BID ADDENDUM 1

Project: Warwick Valley CSD
High School
Unit Ventilator Replacement & Air Conditioning Upgrade

Engineer: Eisenbach & Ruhnke Engineering, P.C.
291 Genesee Street
Utica, NY 13501
E&R Project #: 05-21-04

A-100

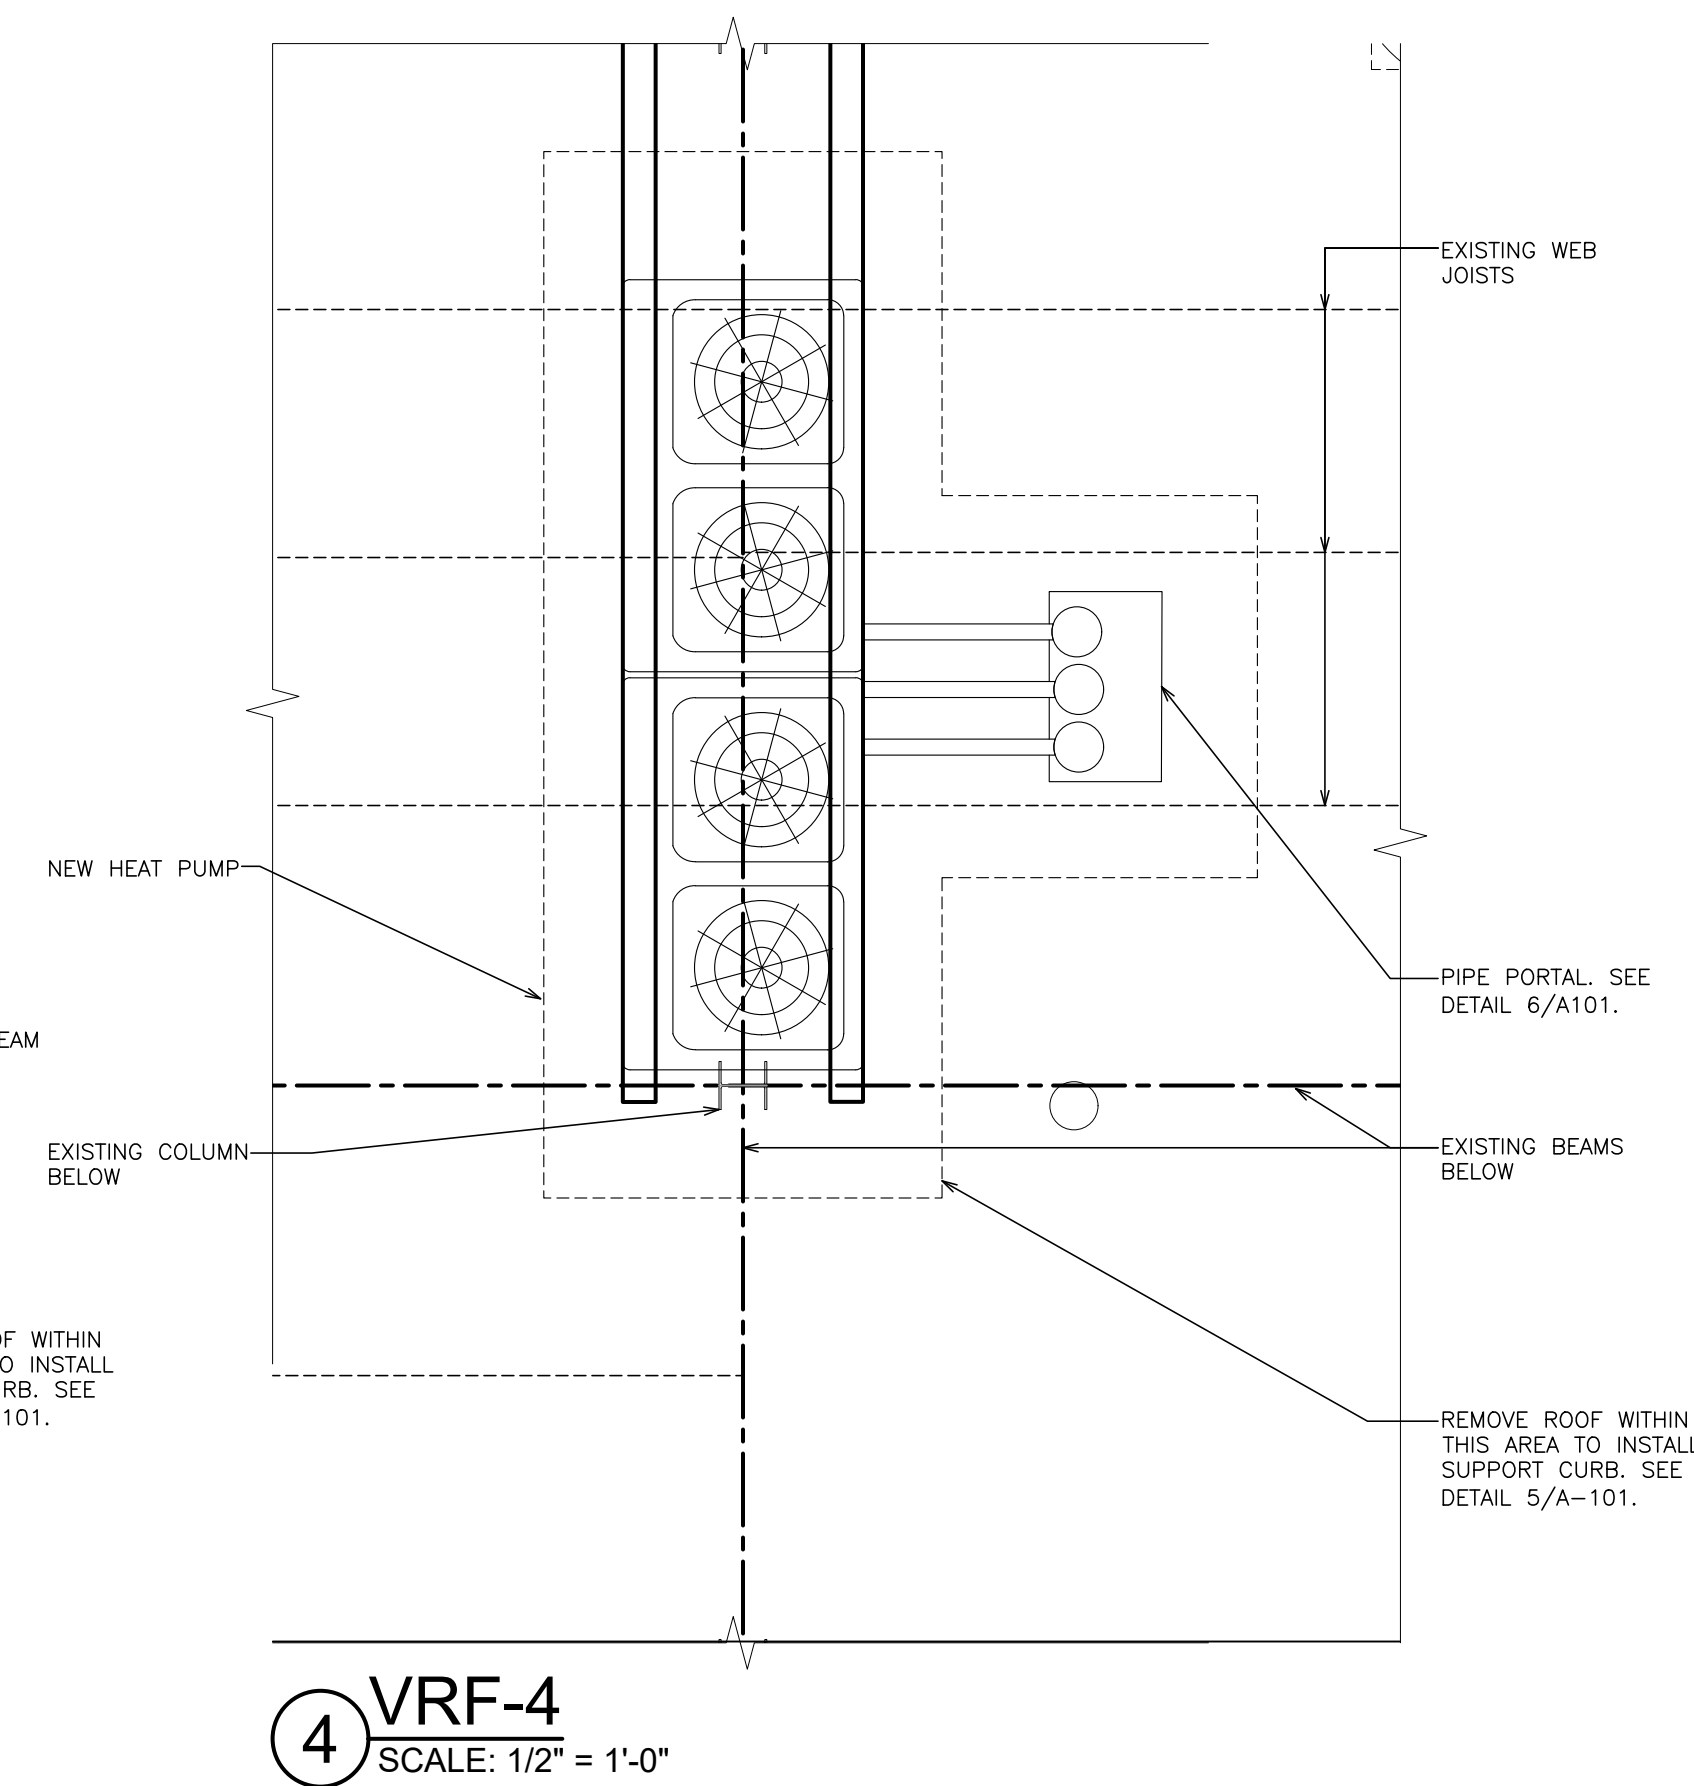
1. Is the masonry on drawing A101 by the MC or the Roofer? Please advise **MASONRY WORK IS BY MC.**
2. Is the flashing on drawing A101 by the Roofer or MC? **ROOF CURB FLASHING IS BY ROOFER.**

3. On detail 6 on drawing A101 the word GC is mentioned. Is this the roofer or the MC as there is no GC bid? Please advise. **IN THIS CASE - GC SHALL MEAN ROOFER.**

PROJECT NO.	05-21-04 05-20-06
BID ADDENDUM ISSUED FOR BID	11.23.2022 11.09.2022
SED SET	10.19.2022
REVISION	DATE
DRAWN BY	
CHECKED BY	
SHEET SIZE	30" x 42"
SCALE	AS NOTED
SHEET TITLE	
HIGH SCHOOL UV-C LIGHT FIXTURE SCHEDULE	
SHEET NO.	
M-503

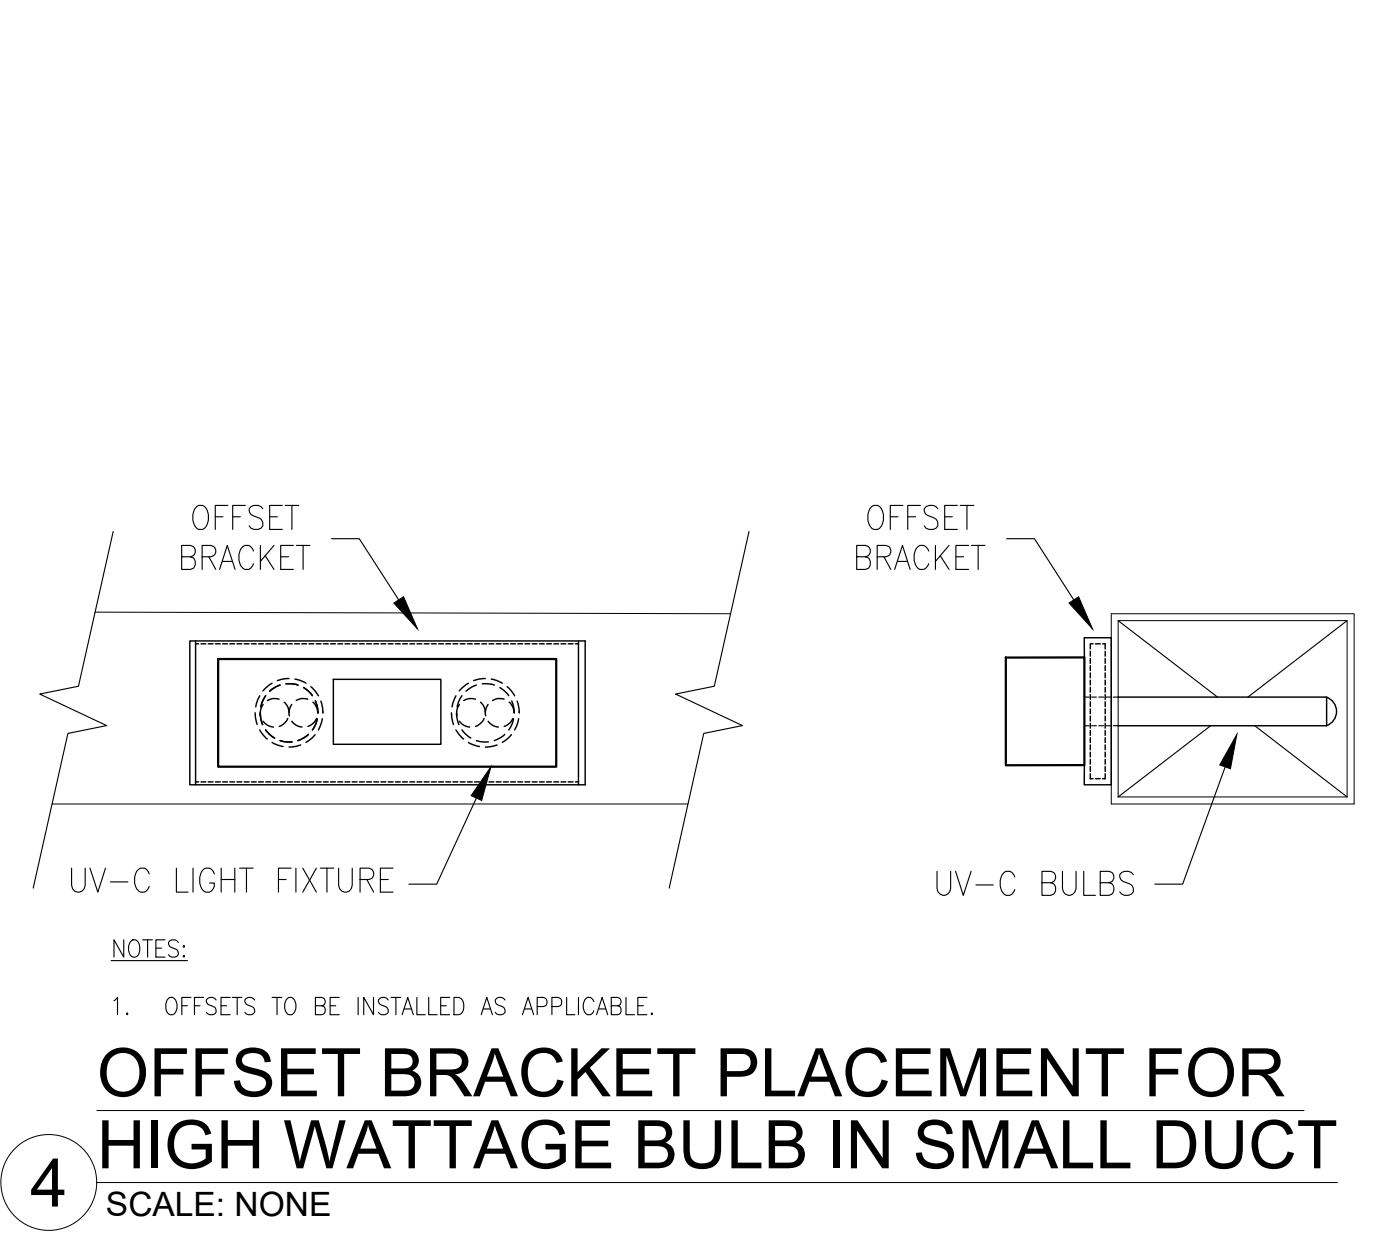
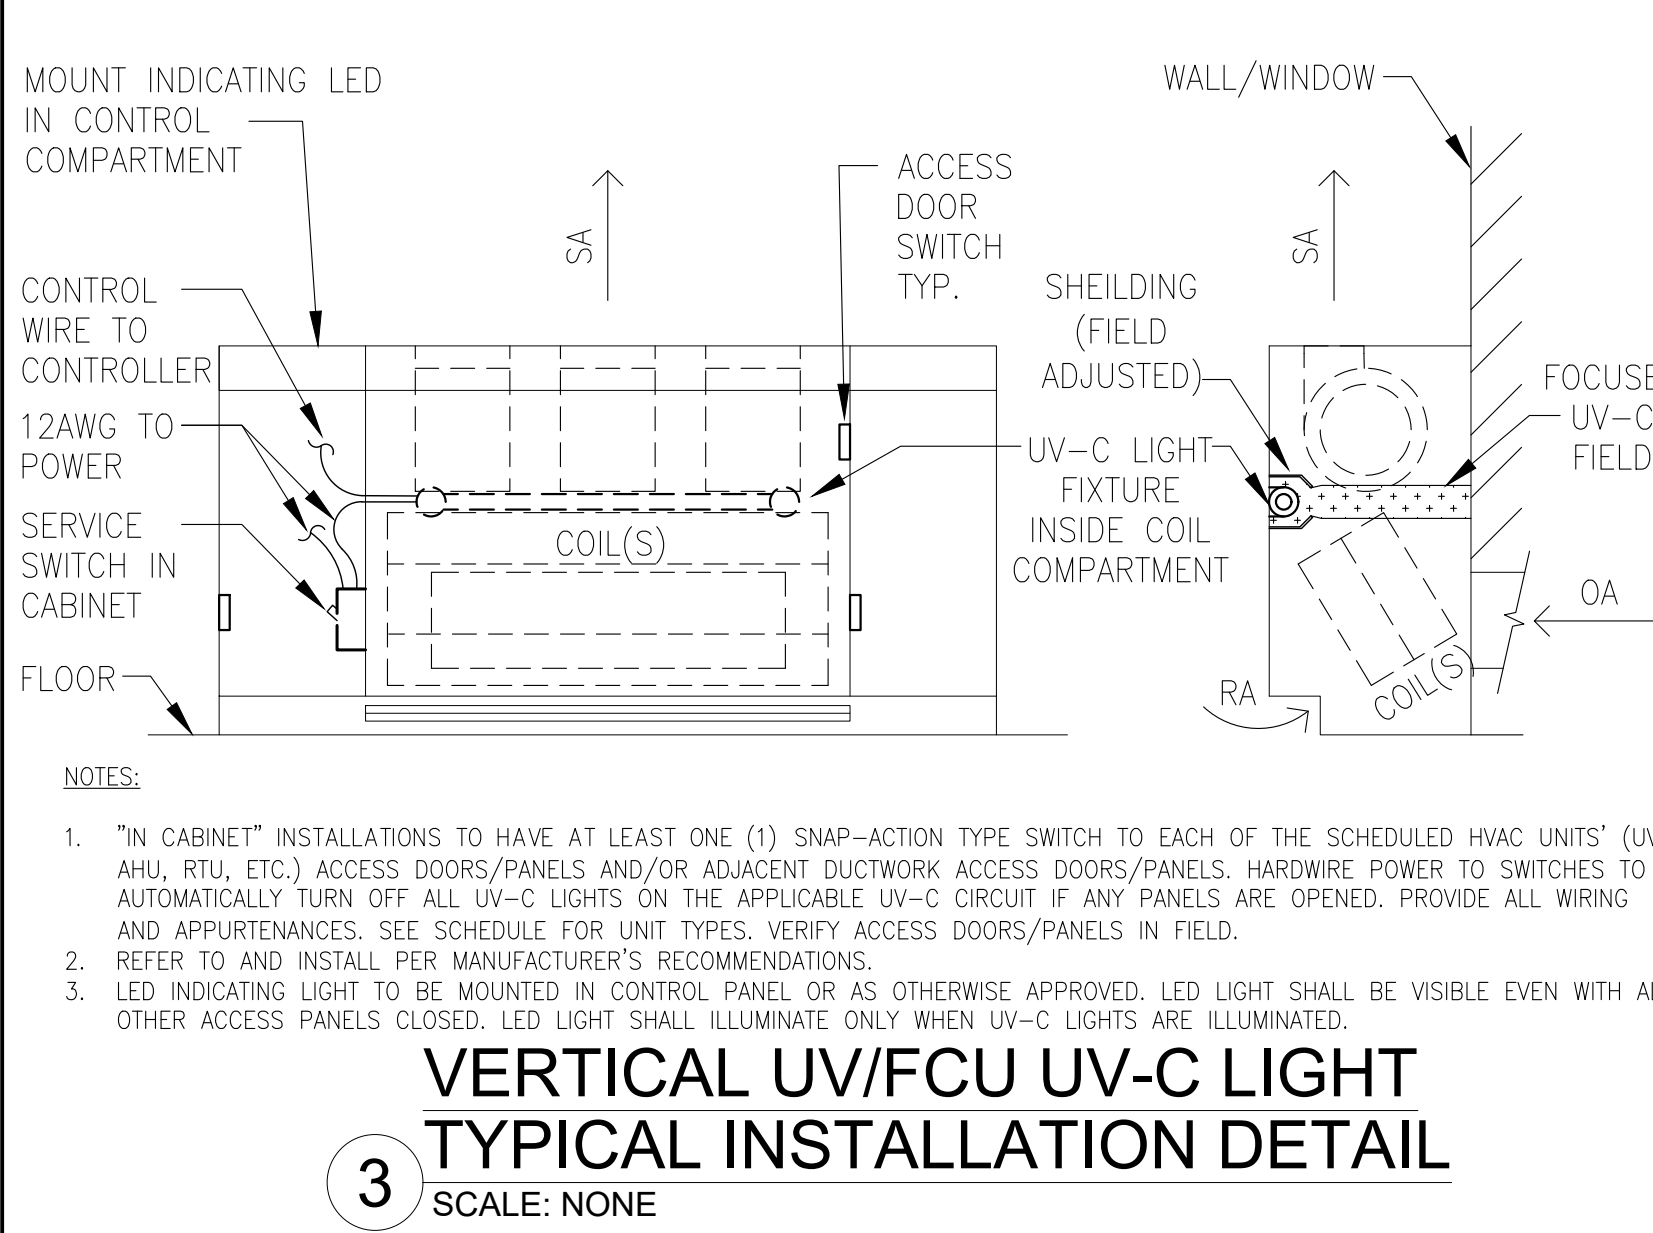
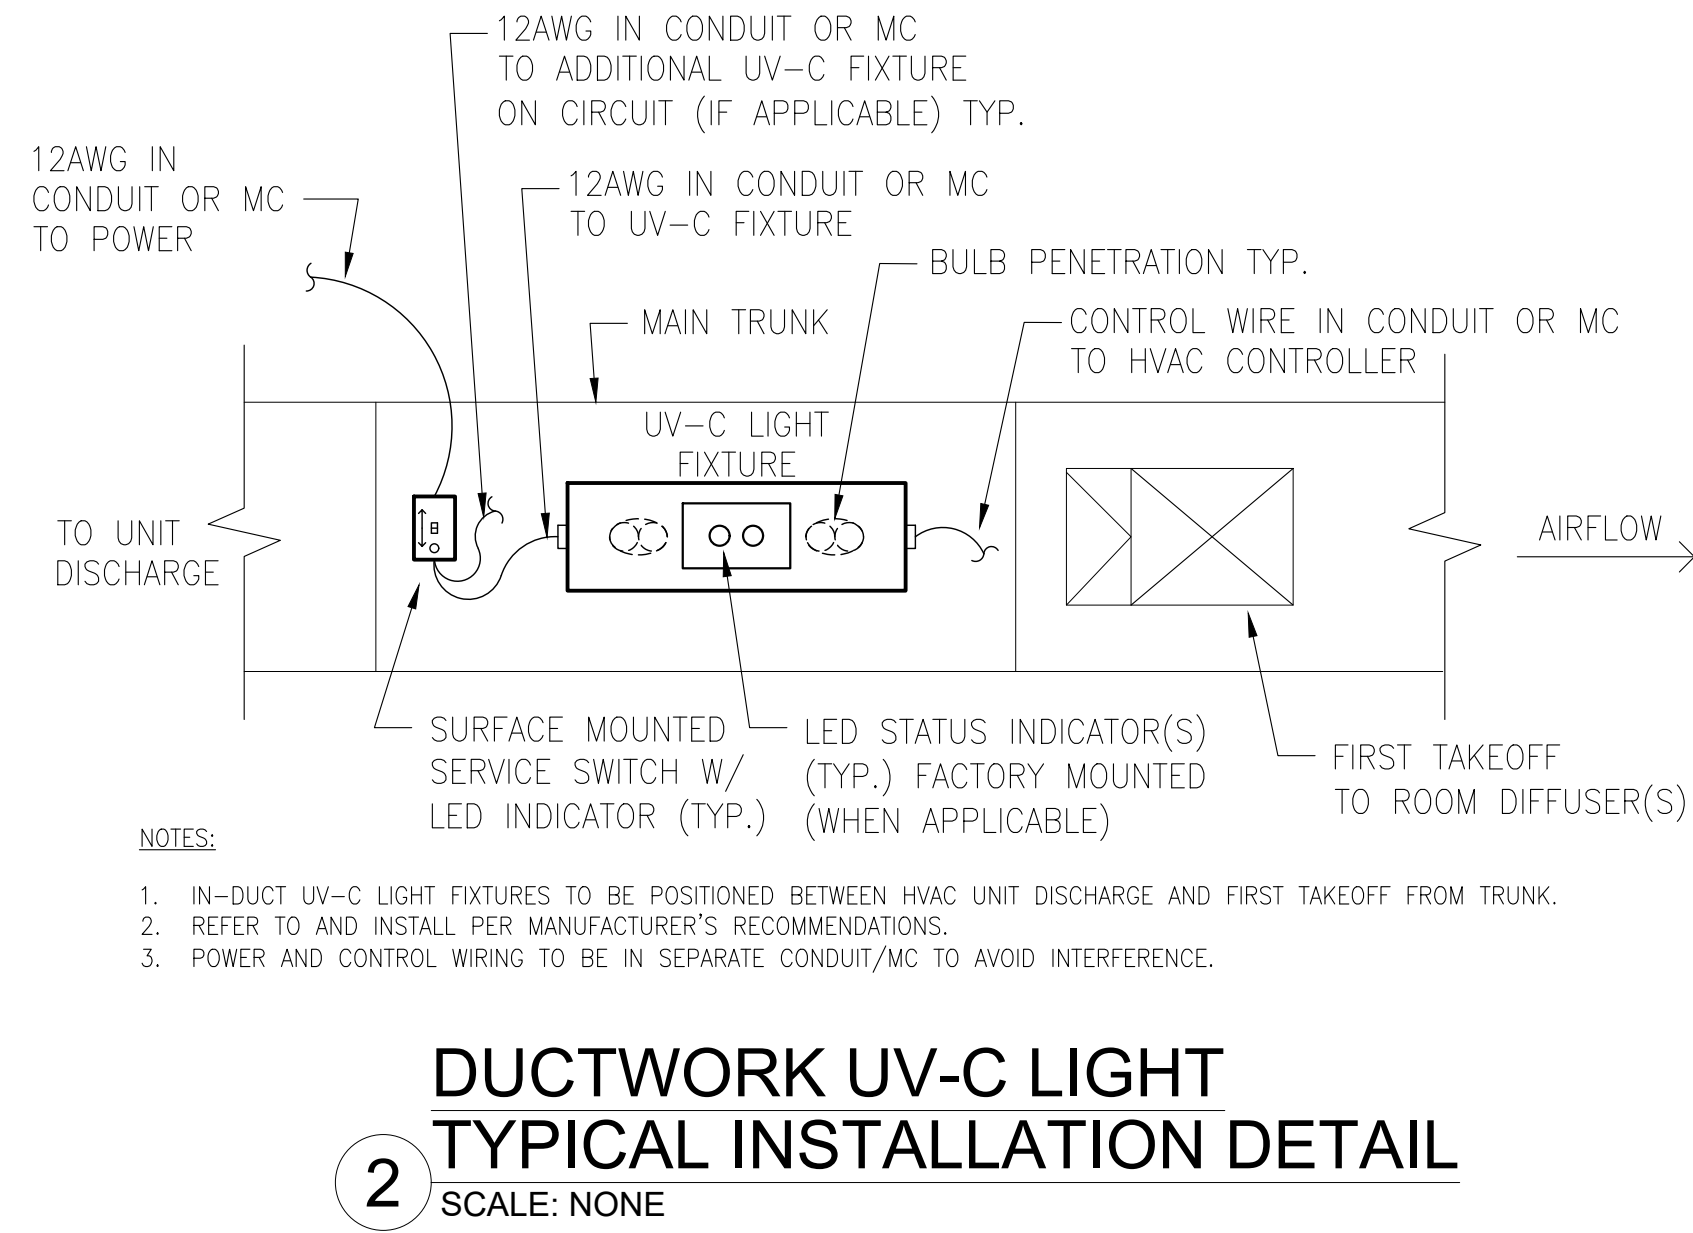
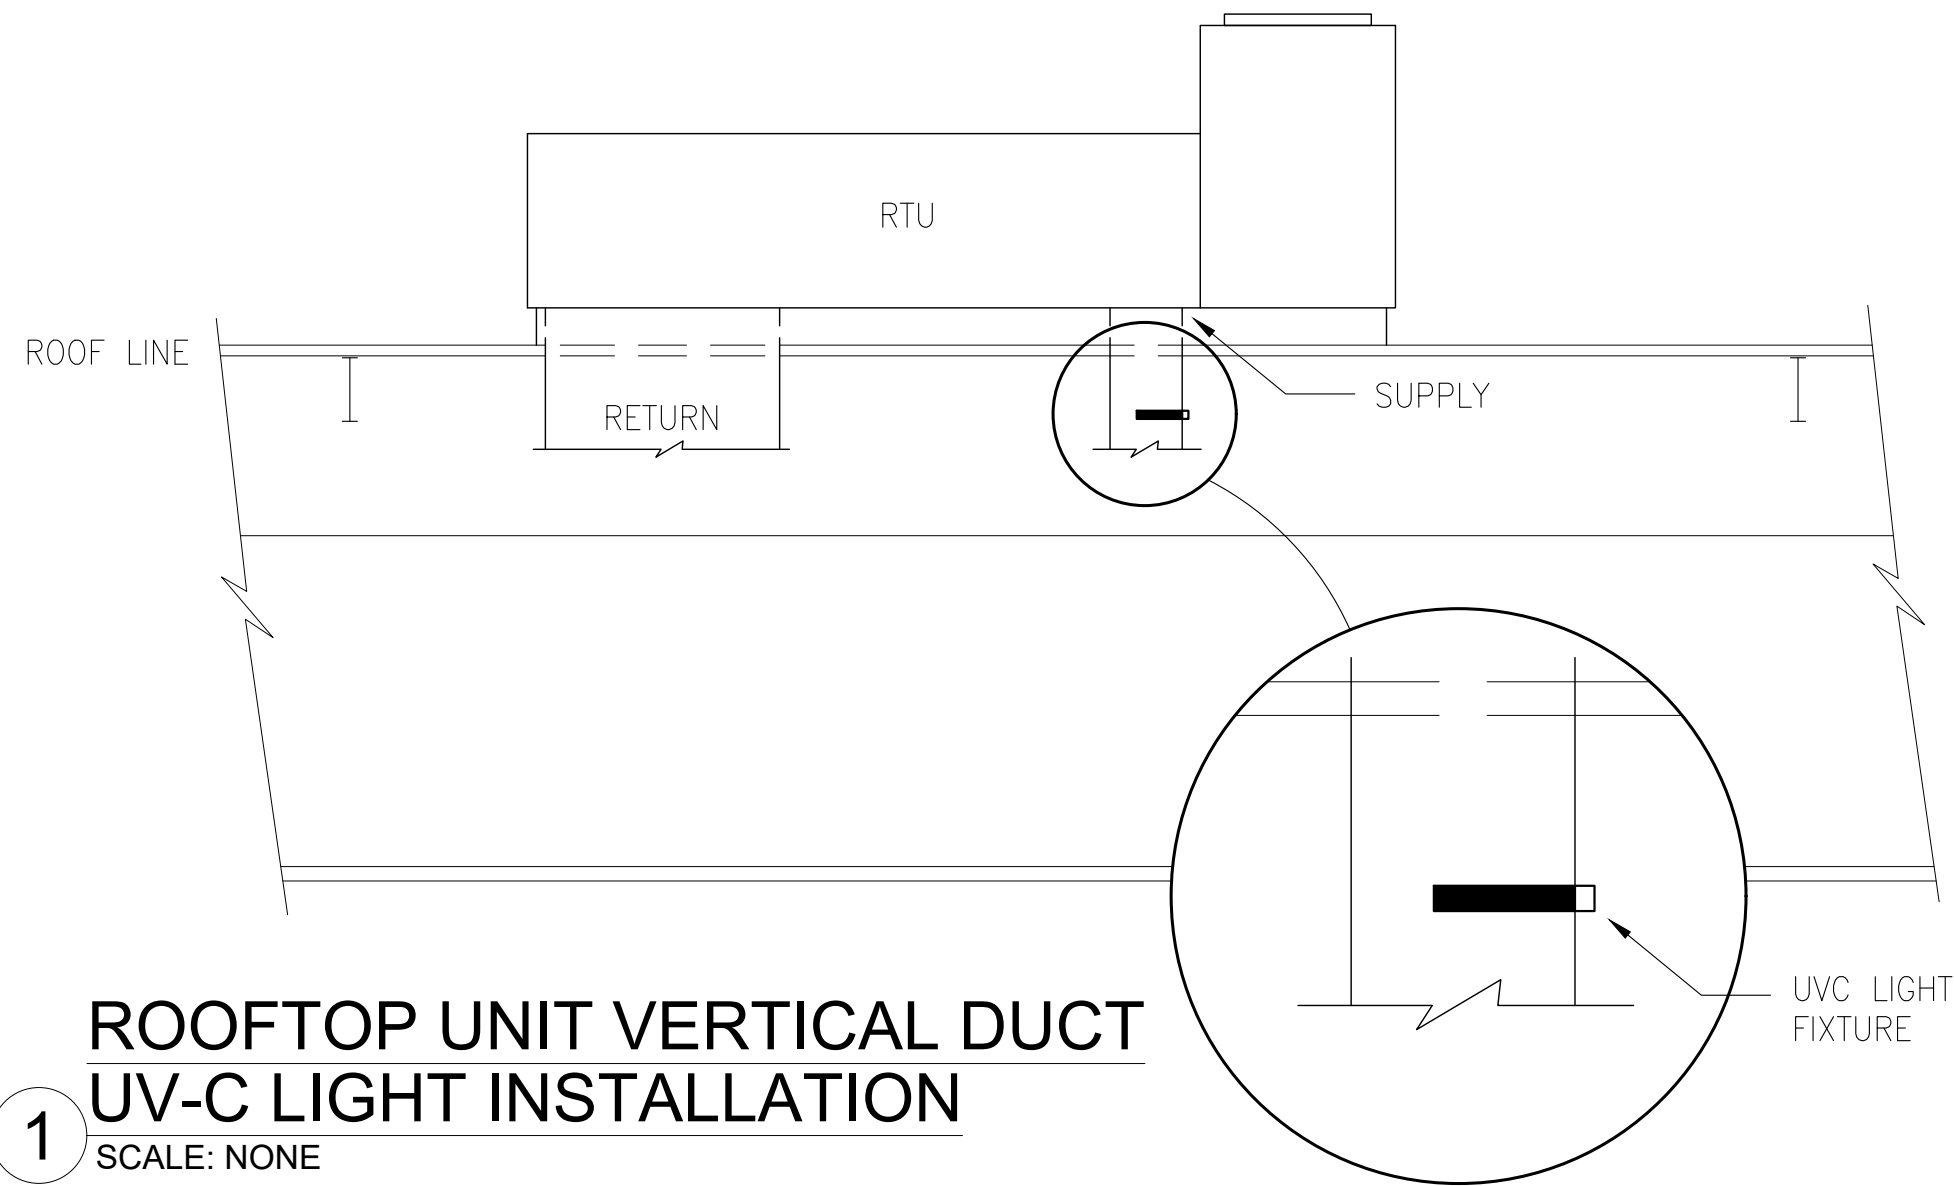
5. The drawings say for the MC to seal, patch and maintain the roof warranty. Is this by the MC or the roofer? **SEE ANS. 5 BELOW.**
6. On drawing M-503 clearly on the lower table, it says the lower table is Alt-H1. On the upper table it says only Alternate. Is the entire drawing M503 Alternate H1? Please advise. **SEE ANS. 6 BELOW.**
